Memorandum

June 17, 2008

TO: Columbia River Crossing Task Force
FROM: CRC Pedestrian and Bicycle Advisory Committee (PBAC)
SUBJECT: PBAC Recommendations for World Class Pedestrian and Bicycle Facilities

PBAC Proposed Pedestrian and Bicycle System for Replacement Bridge

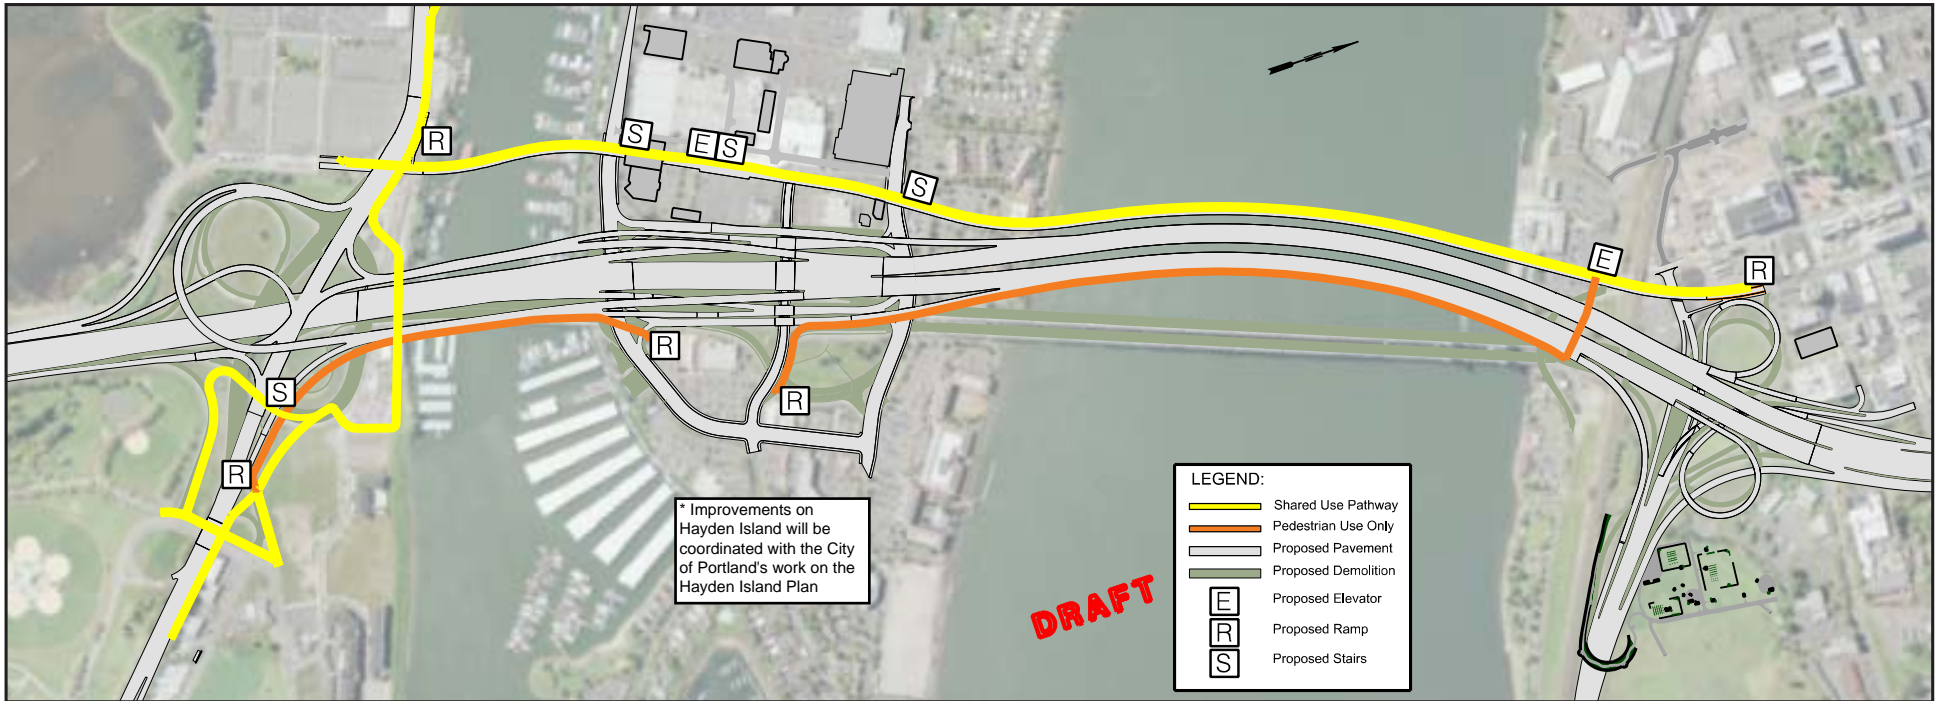
- The overall pathway on the western bridge (adjacent to the transit guideway) must provide separation between recreational users and higher speed bicycle users. To provide this separation, a 12-foot wide regional trail should be provided adjacent to, and to the west of, a pair of six-foot wide bicycle lanes (see attached rendering). These recommended widths are exclusive of potentially needed shy distances, i.e., free and clear of poles and other obstructions to enable safe pedestrian and bicycle movement (a summary of agency standards for multiuse paths, sidewalks and bike lanes is attached).

- In addition to the combined regional trail and bicycle lanes on the western bridge, an eight-foot wide sidewalk should be provided on the eastern bridge (the bridge that would serve the northbound traffic lanes) across both the Columbia River and the North Portland Harbor. The sidewalk across the North Portland Harbor would touch down on Hayden Island and use surface street sidewalks to connect to the sidewalk across the Columbia River.

Pedestrian and Bicycle Advisory Committee Recommended Pathway on West Side of West Replacement Bridge (Looking North)

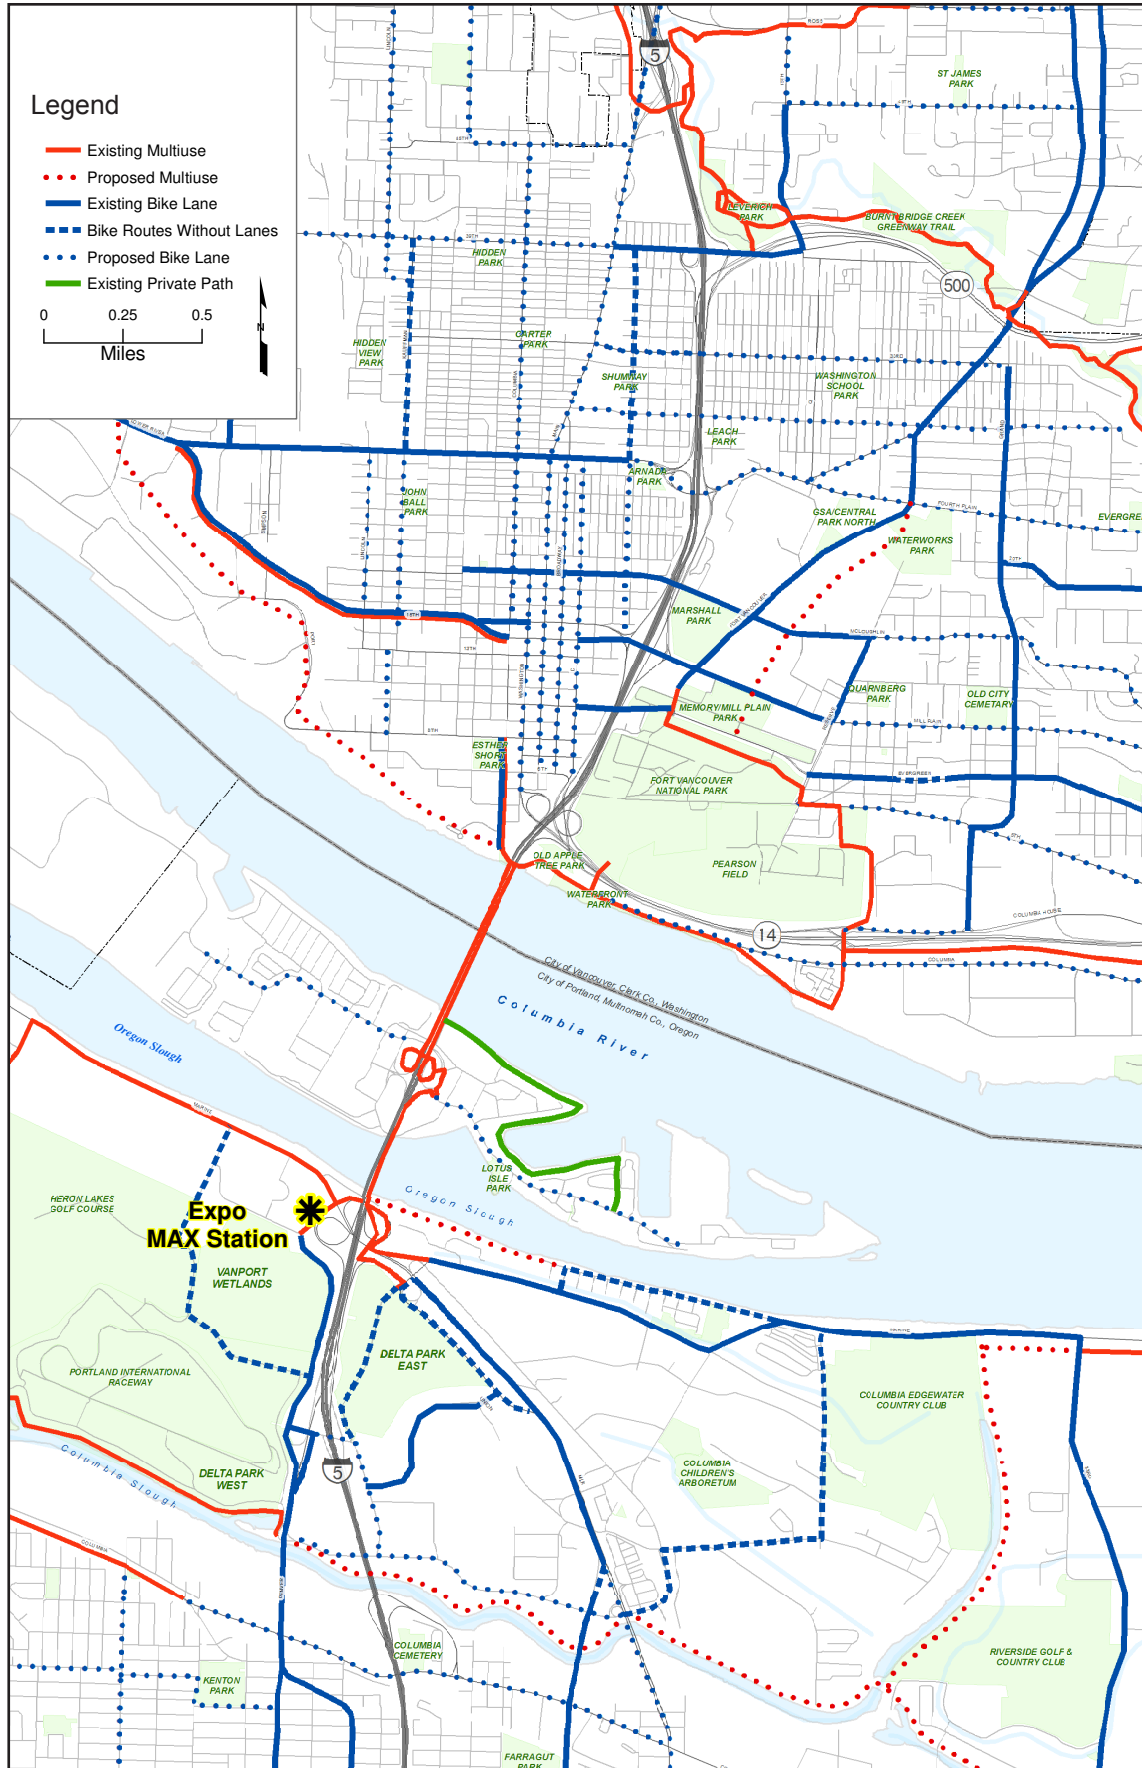
The regional trail would accommodate pedestrians, persons with disabilities, seniors, families with children, tourists, roller-skaters, and recreational bicycle riders. The adjacent bicycle lanes would be used by bicycle commuters and other faster-moving bicyclists. The regional trail would be at a slightly higher level than the bicycle lanes, but bicyclists in the bicycle lanes would be able to access the trail. Different paving treatments and/or patterns should differentiate the regional trail and the bicycle lanes.
